REFERENCE: Docket 50-186  
University of Missouri-Columbia Research Reactor  
Renewed Facility Operating License No. R-103

SUBJECT: Written communication as specified by 10 CFR 50.4(b)(1) regarding responses to the  
"University of Missouri at Columbia - Request for Additional Information RE: License  
Amendment Request to Implement Selective Gas Extraction Target Experimental  
Facility at the University of Missouri Research Reactor (CAC No. MF9524)," dated  
September 7, 2017

By letter dated September 7, 2017, the NRC requested additional information and clarification regarding the proposed LAR in the form of thirty-eight (38) questions (numbered 1 through 38).

Below are MURR’s responses to the September 7, 2017 request for additional information, including enclosures of supporting documentation.

Figure 33-4  
Target Assembly Flow Rate vs. Time – Flow Blockage

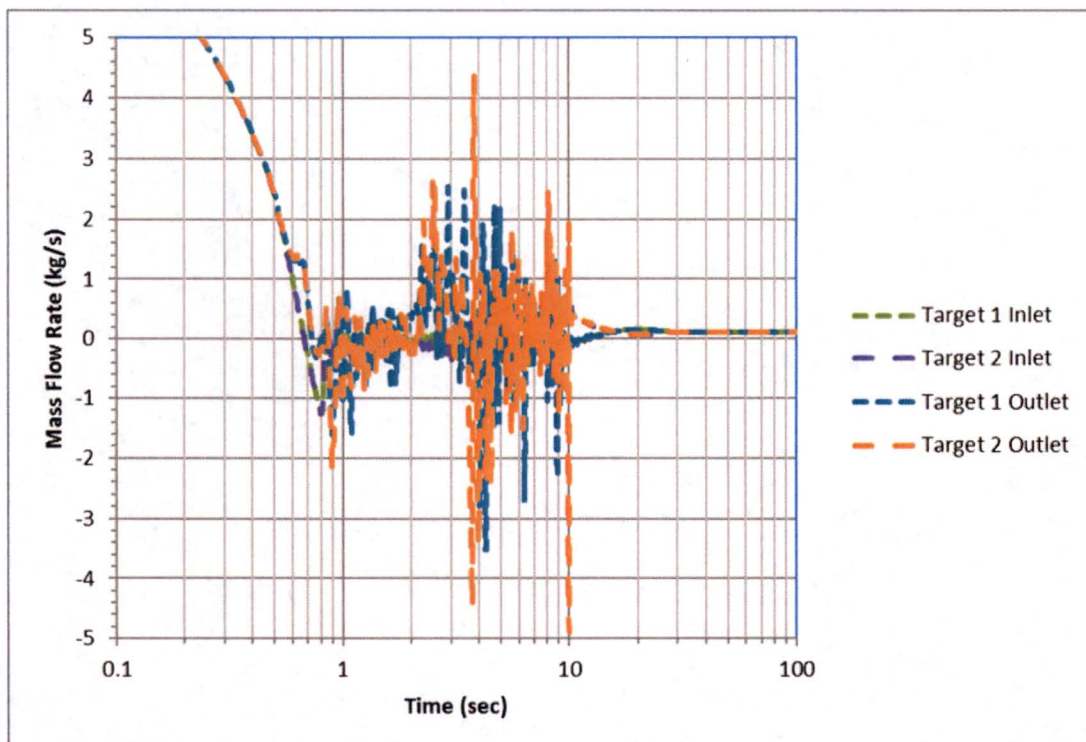
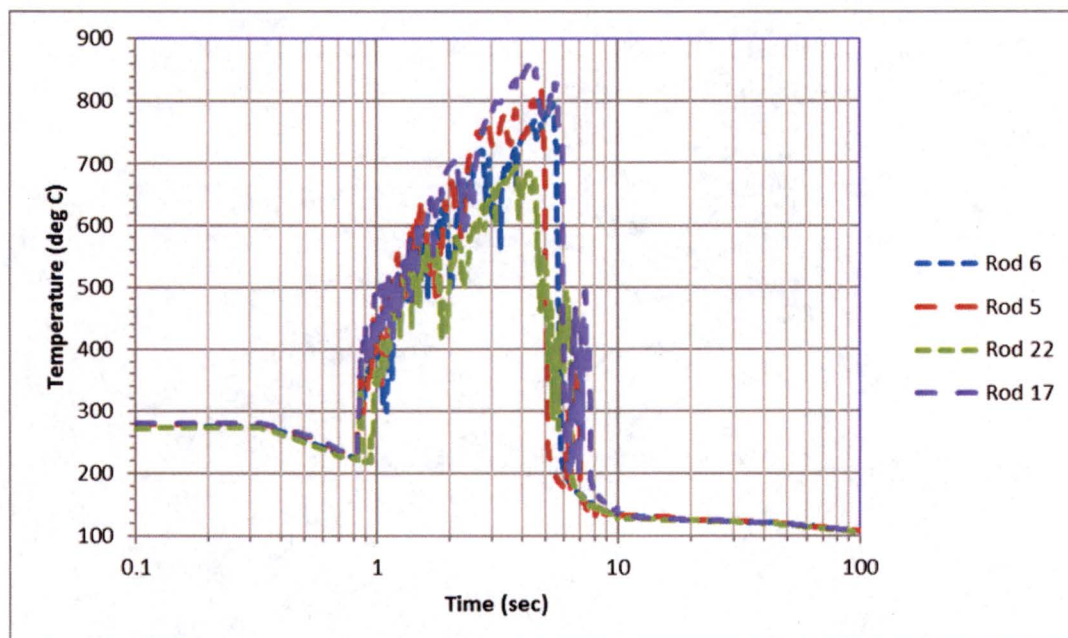
32.3. *Provide a description or analysis of any review of potential break sizes less than a full double ended break to establish the bounding break condition, or justify why no additional information is needed.*

An additional RELAP5 case was analyzed which combined a 90% flow blockage of the suction line filter with a 0.5-second pump stoppage. At 0.6 seconds, shortly after pump stoppage and 90% flow blockage is achieved, the mass flow rate out of the Target Assemblies (TAs) initially shows flow spikes due to boiling and void formation of around 40%. Near 2 seconds, as shown in Figure 33-4 below, flow spikes at the TA exits become more extreme as void fractions experience spikes of 90 to 100%. After 10 seconds, the decay heat level has fallen sufficiently such that the small amount of flow (near 0.1 kg/s) making it through the blocked filter and stopped pump due to thermal density differences is able to remove enough heat to prevent boiling.

Peak cladding temperature reaches 860 °C (1580 °F) after 4.4 seconds, but starts rapidly falling after 6 seconds and is below normal operating temperature before 8 seconds has elapsed, as shown in Figure 33-5. Fluid momentum within the TA, along with boiling and chugging when the flow approaches zero, are able to keep peak cladding temperatures below 900 °C (1652 °F).
